# Desert Sunlight Solar Farm Project California Desert Conservation Area Plan Amendment and Final Environmental Impact Statement

# **Appendix M**

## **Comment Letters**

**Commenter on the Desert Sunlight Solar Power Project  
Draft Environmental Impact Statement**

Image taken from base of Coxcombs – JoTr Wilderness

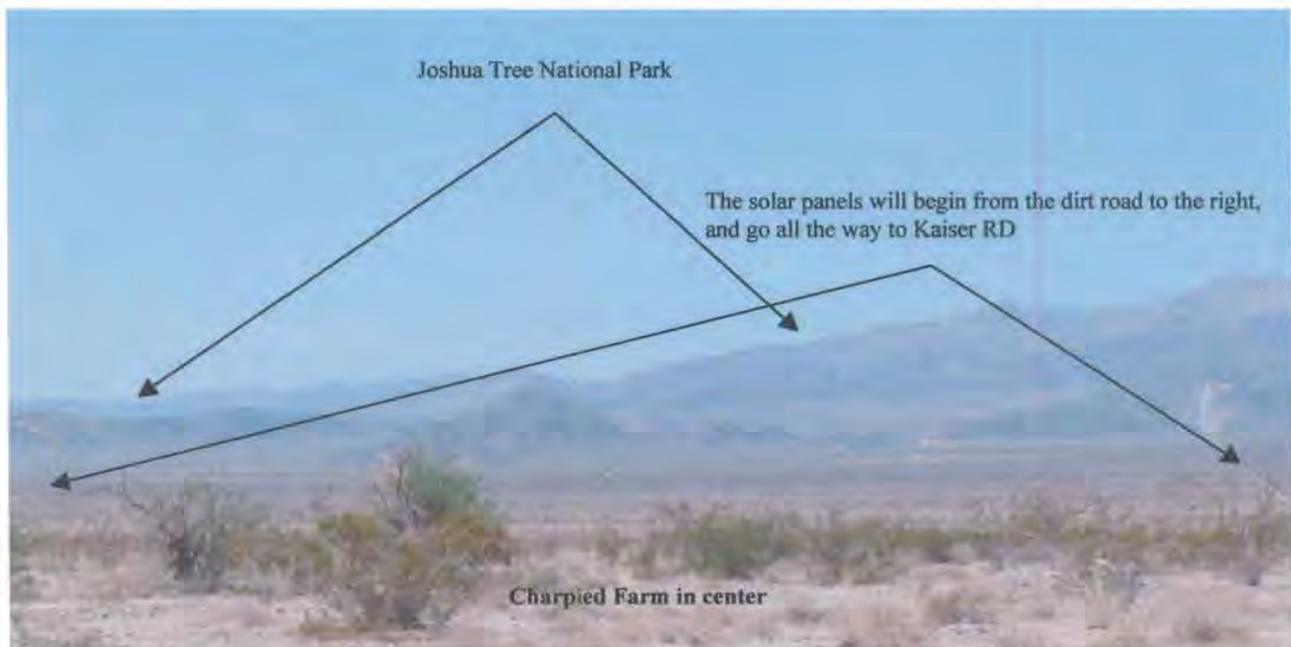
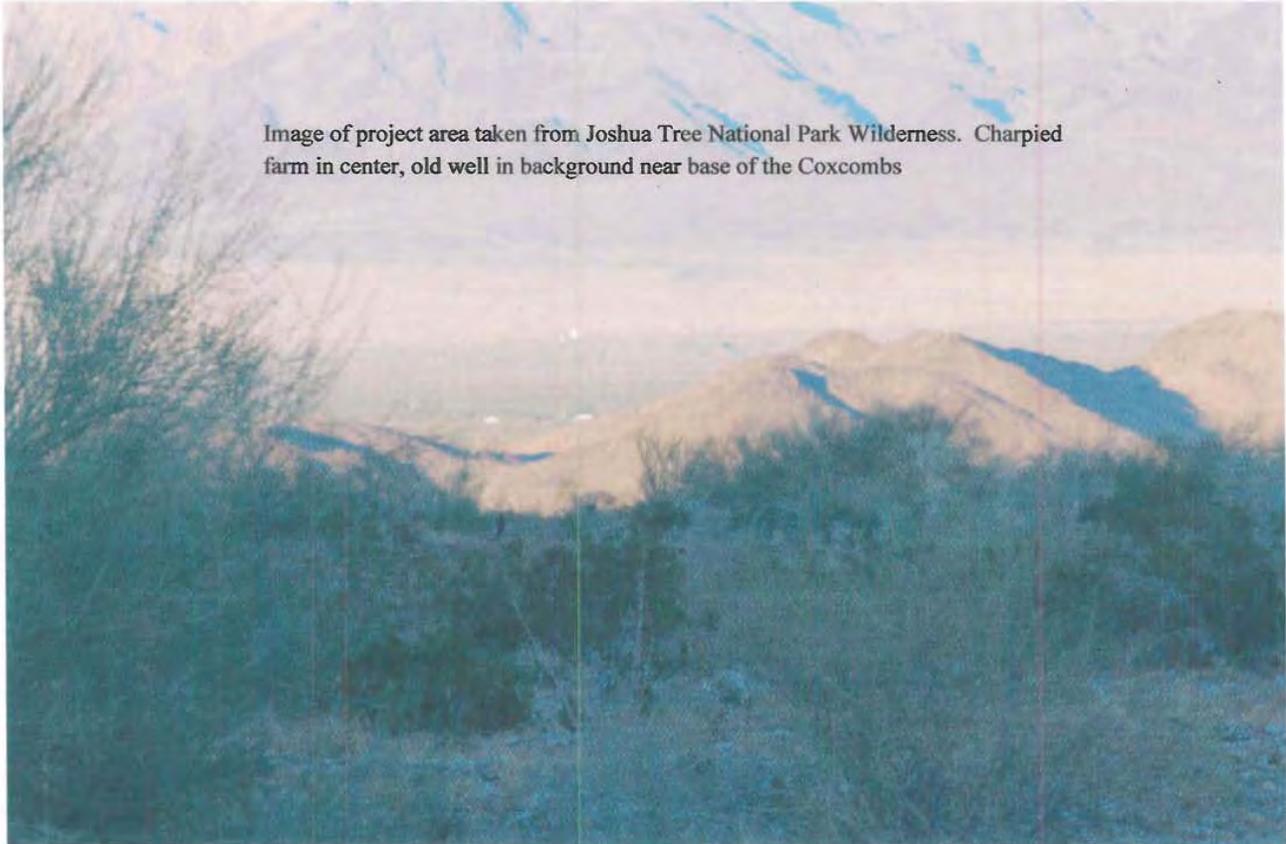
Key Observation Points (“KOP”) that we viewed during the BLM meeting in Desert Center never even attempted to show the project to sensitive receptors. Not one image was taken from private property lines. Further, the private property owners in Section 16 would have to be blind not to see the mirrors. The Charpied’s will not only see the panels, they will hear the constant hum of the transformers and have their eyes assaulted by transmission lines, and panels where Joshua Tree National Park Wilderness once painted the scenery. A visitor’s wilderness experience in Joshua Tree National Park will be impugned.

project 54881  
contract  
dwg. no. TAN-1 rev. 1

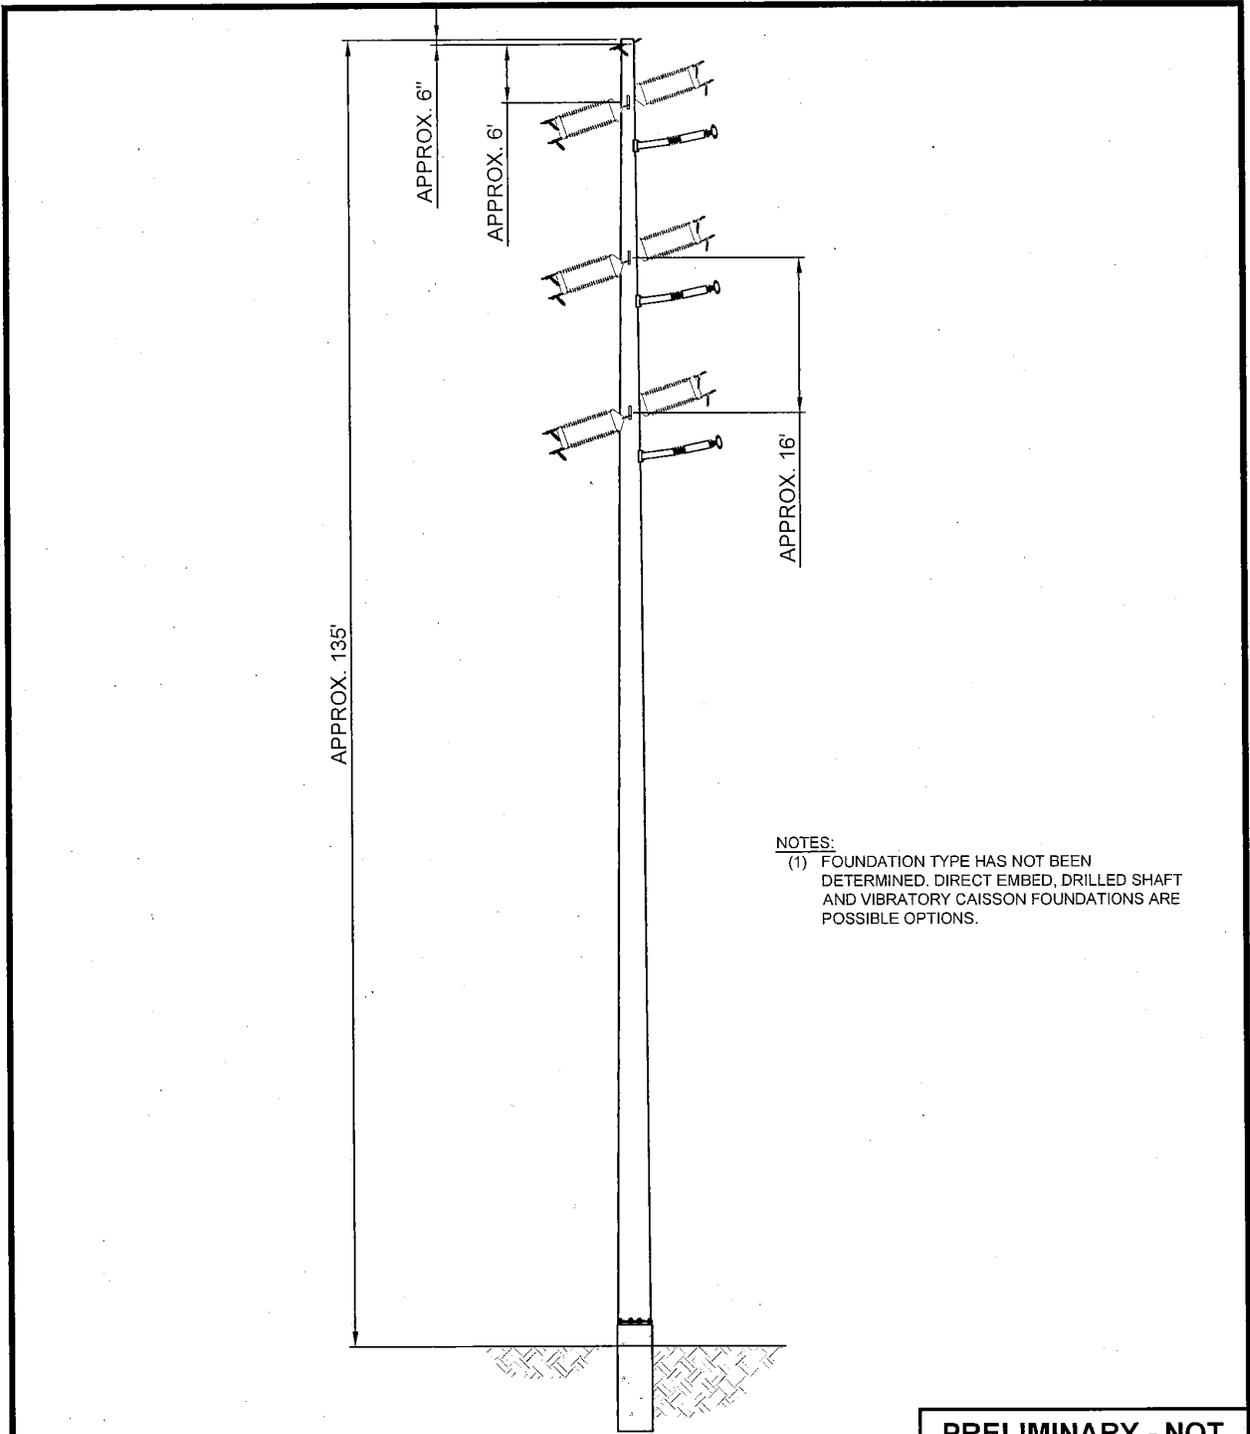
**2.2.3, p. 2-18, second paragraph of “Transmission Line” section and Figures 2-10/2-11.** First Solar has revised the design of the Gen-Tie poles from a delta to vertical configuration. We are therefore submitting revised figures to replace Figures 2-10 and 2-11, which are new figures TAN-1 and DE-1, respectively, and which are attached to this submittal of DEIS comments. This design change does not impact the height or footprint of the poles, the typical spacing between the pole structures, or the construction process for the Gen-Tie. The text in the second paragraph should be revised with the following:

“The Applicant plans to use steel monopoles for the Gen-Tie Line. Poles are expected to be approximately 135 feet tall. Typical 220-kV poles designed with a vertical configuration are shown in Figure 2-10 and Figure 2-11. Typical spacing between structures would be approximately 900 to 1,100 feet. Self-weathering steel would be used for the monopoles, which would blend with the surrounding mountains better than other potential finishes. Self-weathering steel is composed of a special alloy that forms an oxide, which prevents further rusting. The finish appears as a matte patina and is commonly used in environmentally sensitive areas where a shiny appearance would be undesirable.”

See attachment A (TAN-1 and DE-1 to replace Figures 2-10 and 2-11, respectively).

**DESERT SUNLIGHT**  
**TYPICAL CROSS SECTION ALONG**  
**KAISER ROAD**  
**220 KV LINE**

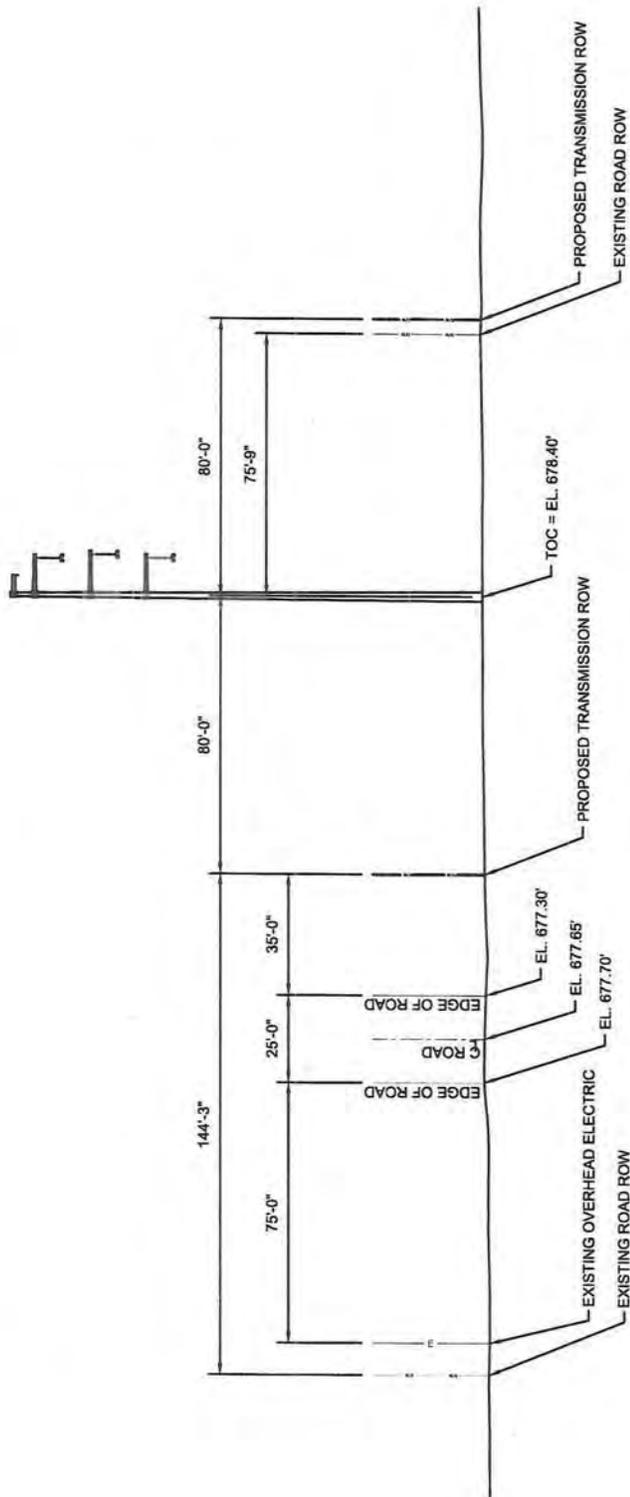
GT-B-2 would cross and encroach on the county roadway easements for Kaiser Road and Eagle Mountain Road as well as land owned in fee by MWD. The approximate aggregate gross acreage of these crossing and encroachments is 101 acres. The table below provides a list of the APN's and associated Section, Township and Range where crossings or encroachments would occur:
